SERVICE BULLETIN

SUBJECT: NOSE GEAR STEERING/TRACKING IMPROVEMENT

S/N AFFECTED: All Mooney Models M20C,D,E,F,G,J Series aircraft up to:

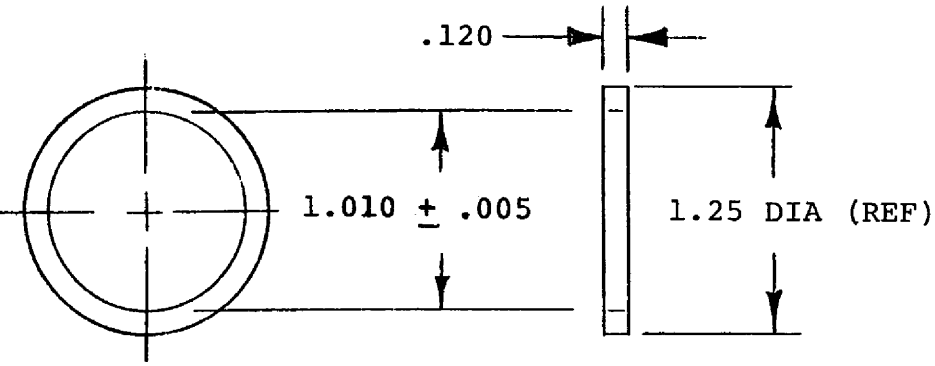
1. Level aircraft per Service & Maintenance Manual.
2. Center nose wheel.
3. Place plumb line over and forward of nose gear trunnion (see illustration) part number 540001-503.
4. Measure forward from aft edge of plumb line to axle center line. Modification relocating nose wheel should be accomplished if axle position, forward of plumb line, exceeds .06.

- 1. Add SB 20-202-3 spacer under 510027 collar.
- 2. Run gear through up/down cycle. Check nose gear door and wheelwell tire clearances. Re-rig gear if required.

SB NO. 20-202-3 SPACER
1-1/4" O.D. x .120 STL TUB.
4130 COND. N
FINISH - ZINC CHROMATE PRIMER
